REGISTRATION OF OCCUPATION CERTIFICATE WITH COUNCIL

Full Property Address: 44 Hillcrest Ave Newport
Proposed works: 2 storey dwelling, Swimming pool
Type of work: Building work.
DA no/CDC No. N1204/99 **Determination date:** 3/3/00

OCCUPATION CERTIFICATE

DIRECTORS

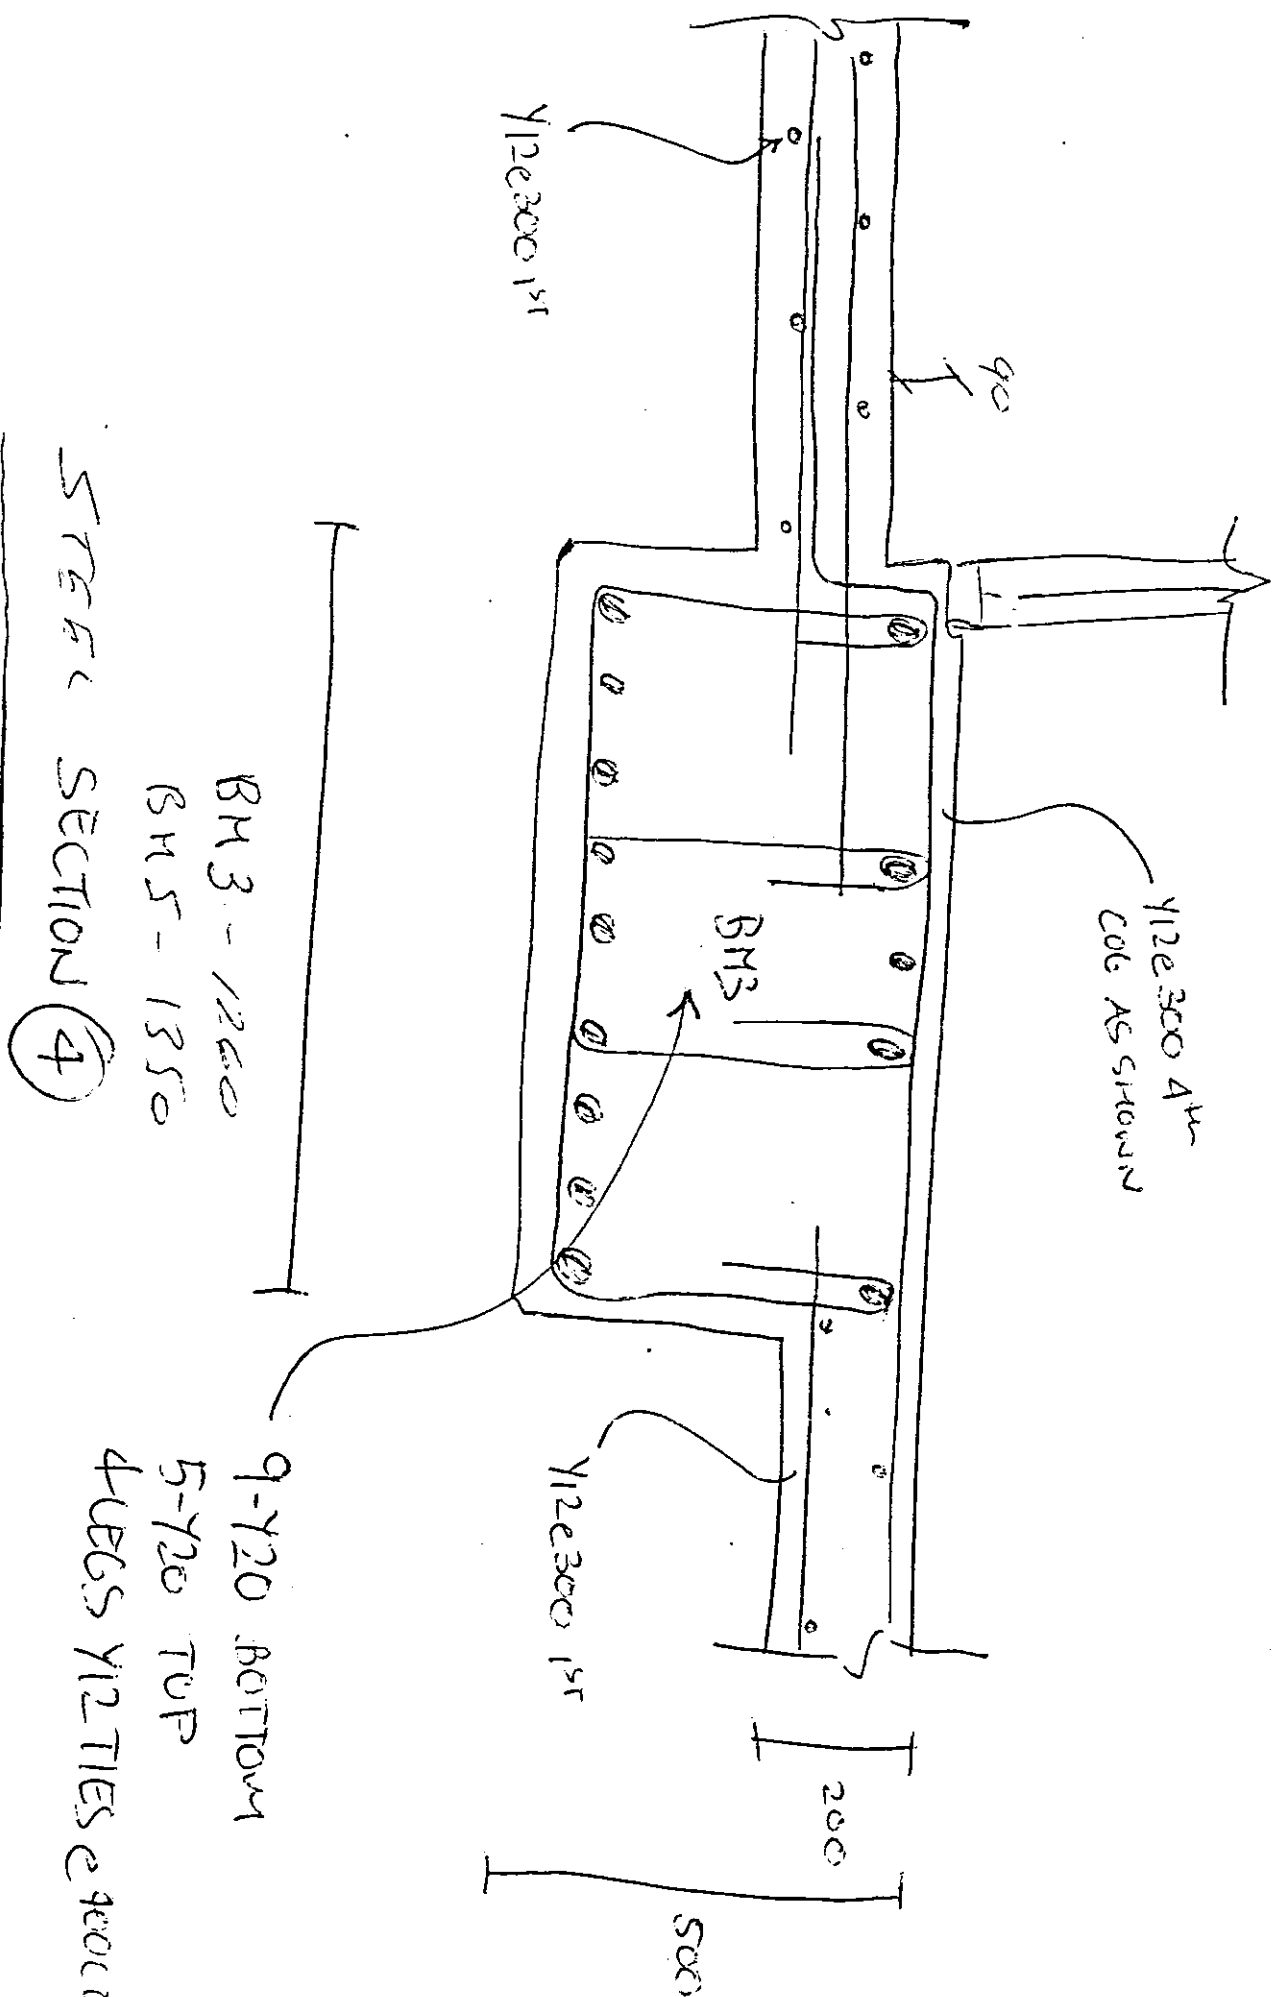
ORC WD4A

SECTION 1
WD4C

INCLUDE 3-Y12 TOP & BOT.
OVER COLUMNS

230 WIRE O'HANG FOR UPSTAIRS
BATHROOM NONE EXTRA REQD

3) SECTION 4
WD4C

18M 9 HAS 75 MM O'HANG
INCLUDE STEEL SUPPORT BY
EXTENDING BOTTOM Y12 REQD
ORC WD4C SECTION 4

10) SECTION 9
WD4C

NO STARTER BARS REQD.

11) SECTION 5
WD4C

SLIP JOINT REQD YES
EXPANSION JOINT REQD YES.

12)

2-Y32 BARS TOP & BOTTOM
END AT POOL ENDS.

13)

EXTRA OUTSIDE POOL REQD
S12 AT 200 CRS

G.F. SLAB - SITE QUERIES.

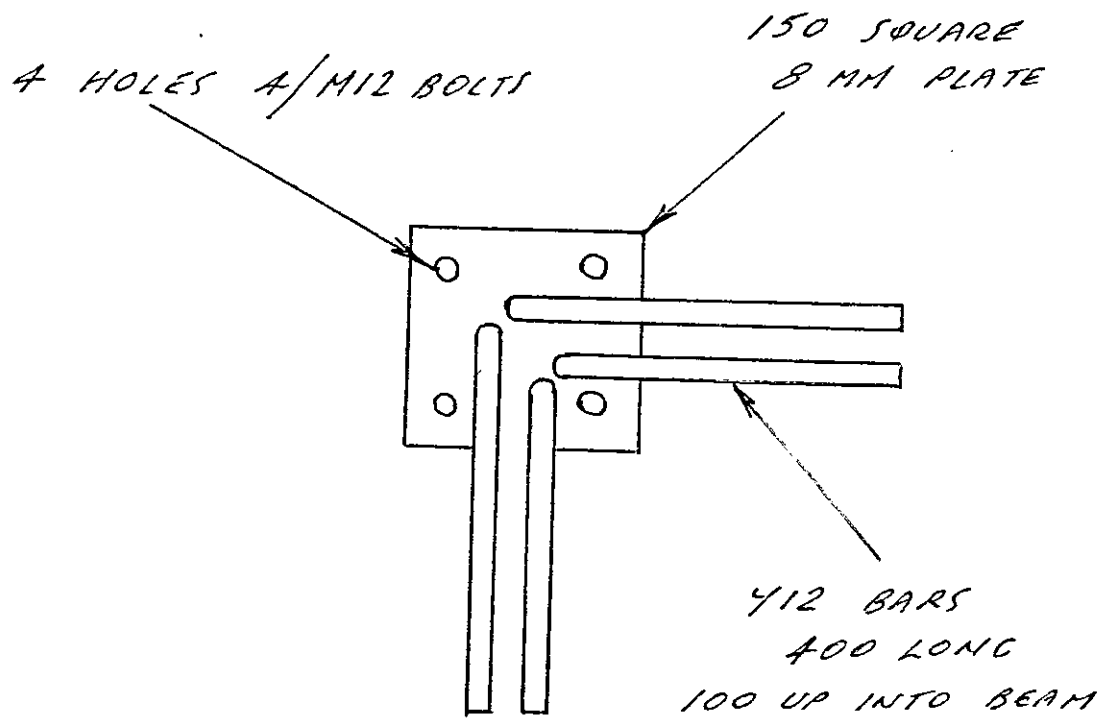
At concrete column add 4×12 'L' bars.
LAP WITH COL. BARS 600. 200 LG COG AT TOP OF BEA
BDM REINF AT BEAMS.

WHERE COGS CUT AWAY - O.K.
FOR REINF. AT BEAMS.

ADD 4×12 $\frac{500}{300}$ BARS.

At cantilever beam use 2×12 FOR 1416.
THEREFORE 6×12 REQ'D

NOTE TO BE CHECKED G.F. TO BASEMENT

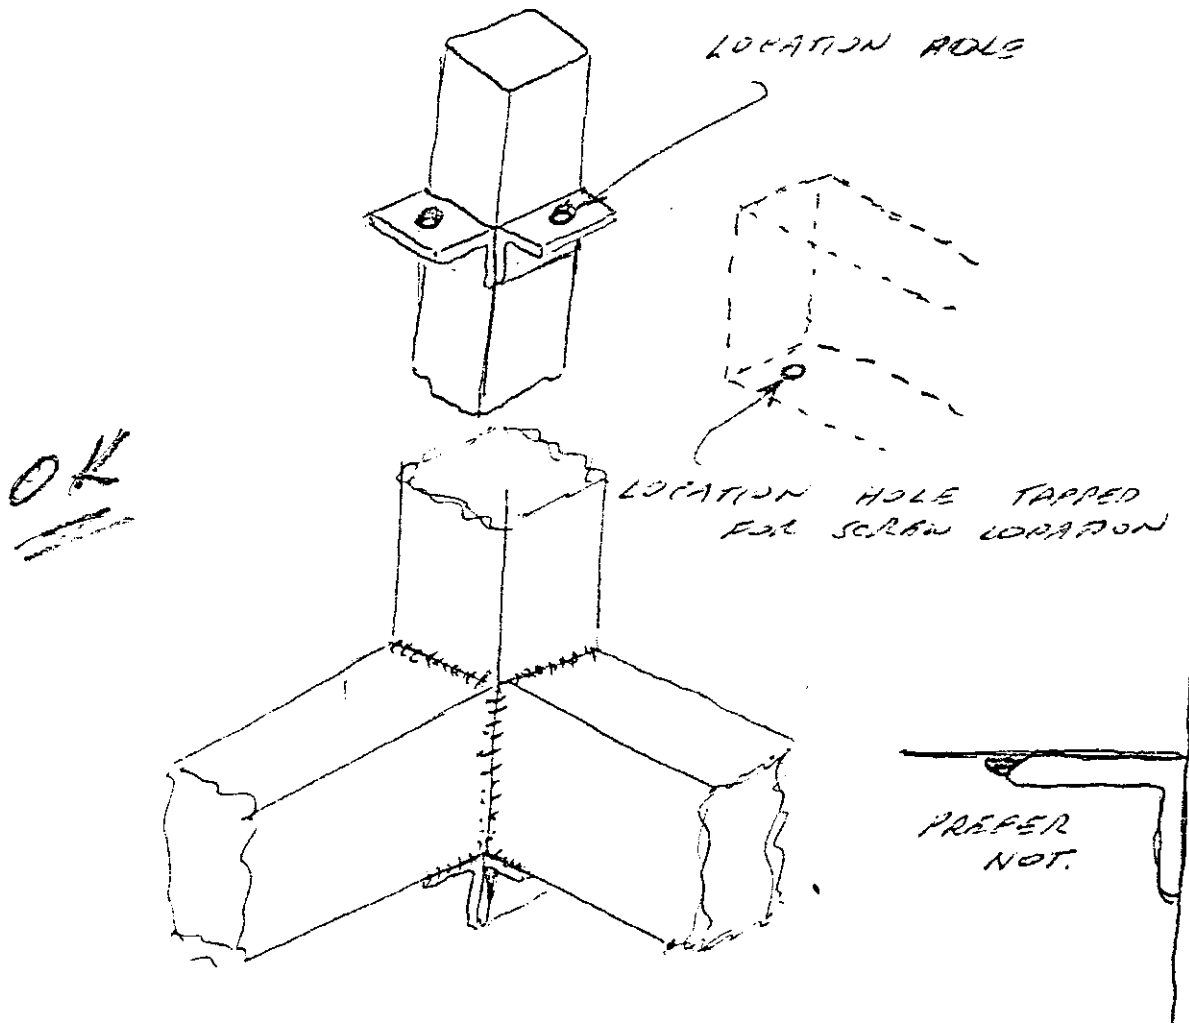
I have enclosed two (2) copies of garage floor plan with slab plan showing different column arrangement.

I need steel details for two (2) only 600 x 400 columns which I have shown over a 1200 wide footing.

Can you complete with sketch and forward same to me?

1. PERIMETER BEAM CONNECTION

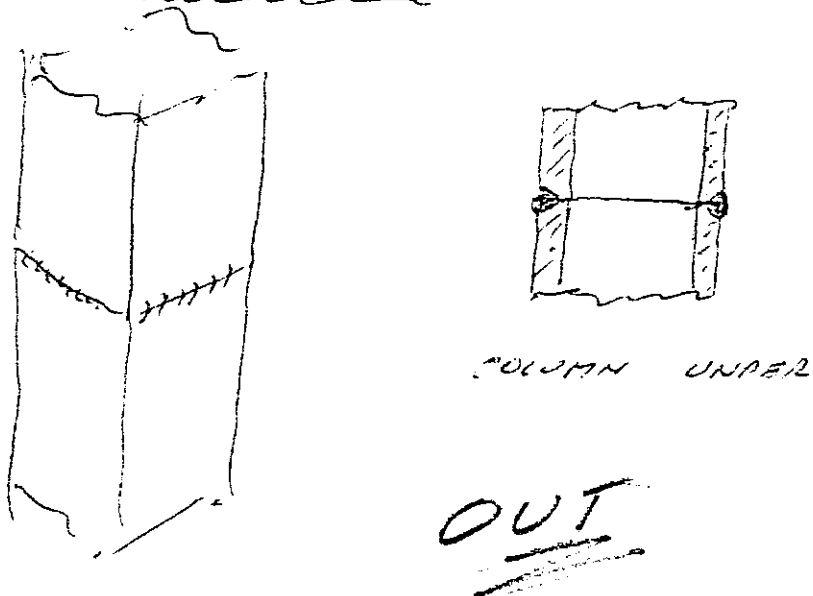
1. STAIRCASE REINFORCEMENT ✓ LM TO
DETAIL
2. KEY LANDING TO CHURCH
THICKEN GROUND FLOOR SLAB & LANDING D35 ✓
3. BRICK PIER IN LIEU OF 109 DRG S10 ✓
SLAB THICKENED TO BEAM DEPTH OVER ENTRANCE
4. WATERPROOFING MEMBRANE DRG S05 ✓
5. STEEL COLUMN HEAD DETAIL UNDER SLAB OR BEAM
TYPICAL 1014 DRG S10 DETAIL LM
6. 100 MM ϕ VENT FROM TOILET THRU SLAB. ✓
7. DRG S12 LANDING FOR WINDOW CLEANING
WIM 250 THICK ✓
8. GALVANISED REINFORCEMENT TO 1ST FLOOR SLAB. NOT REEP?
9. BOX CUTTER ~~40 DEEP TO 110 DEEP TAPER.~~ OK
AT DOWNPIPE END. CAN PROVIDE COLUMN
UNDER AT DOWNPIPE END 75 OR 89 IF
PREFER 75 x 75 DRG S17
ALSO BEAM JOINT DETAIL.
10. BOX CUTTER SIZE RB10 DRG S10 DETAIL
LM
WHAT MAX SIZE ALLOWABLE?
11. DRG S17 PURLIN CONNECTION INBOARD
WIT 4 BOLT SYSTEM? ALSO GRD B?
PURLIN NOTCHED OVER PLATE? CHECK
LM
12. PURLIN C/HAVE 900 MAX FRONT BEARDON

2. COLUMN JOINT PERMISSABLE

WD-2B

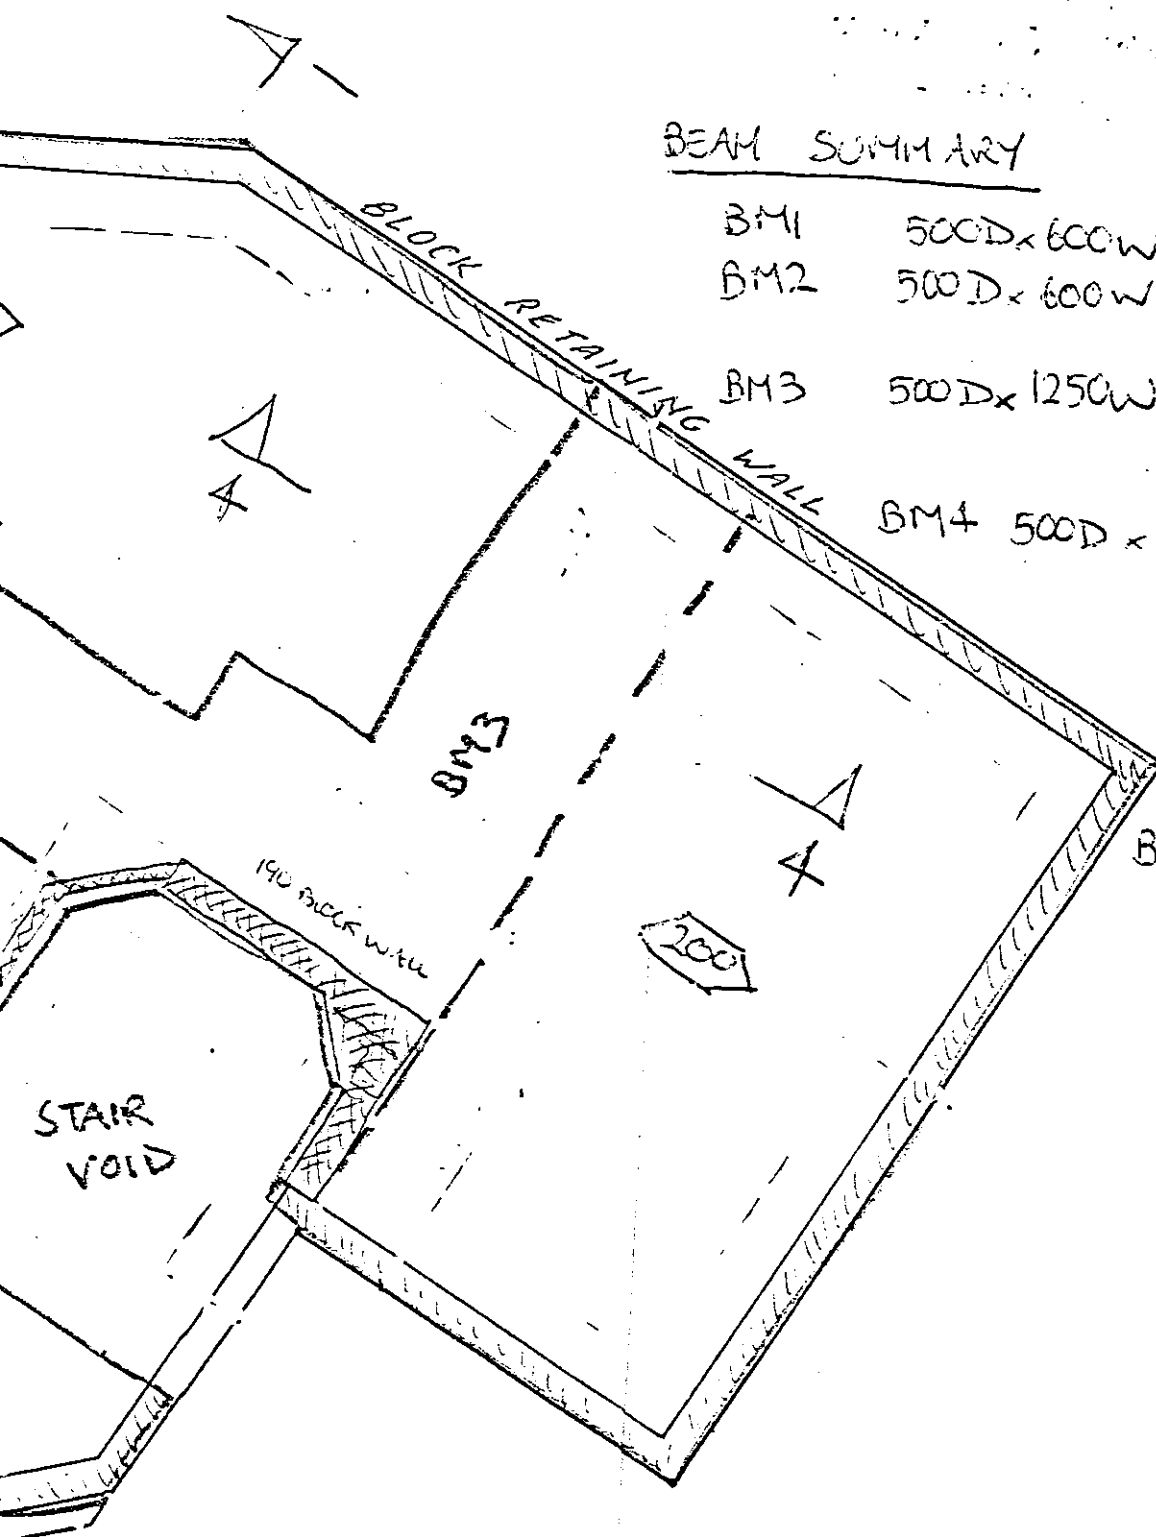
1. Footing arrangement for garage wing walls. ✓
2. Revised footing plan driveway. ✓
3. Location Col CC3 and footing. ✓
4. Planter boxes deleted. ✓
5. Footing detail CC1 and CC2. ✓

1. Revised beam details 600 depth to 500. ✓
2. BM3 1500 wide extra bearing at stairwell. ✓
3. BM1 steps now 100 then 200. ✓
4. BM2 terminate at CC1? ✓
5. CC1 and CC2 details. ✓
6. BM2 rear flush with CC1 and CC2. ✓
7. Revised shape to follow basement walls. ✓
8. Pool pipe penetrations (wall thicker). ✓

1. Architect drg D55 shows window columns. ✓
2. D41 shows slab over no brick head or beam. ✓
3. D55 cavity wall relocate. ✓
SK8 detail cavity wall. ✓
4. Column base and head details SK9. ✓
5. Stair column support (circular aluminium) ✓

1. Revised construction OK. ✓
2. Slab and beam support OK. ✓
3. Revised drain system to balcony. ✓
4. Taper to beam end reqd for 2100 compliance u/side beam 2050 above level courtyard. ✓

1. IBM2 finish at brick wall delete IC10. ✓
2. IBM7 return back to pool side. ✓
3. Increase slab area of lounge and move bulkhead to IC4 see D-48B. ✓
Support lower slab off side of IC4. ✓
4. IC8 and IC7 located within brick wall. ✓
5. IBM8 located over stairwell wall with study wall adjacent. ✓
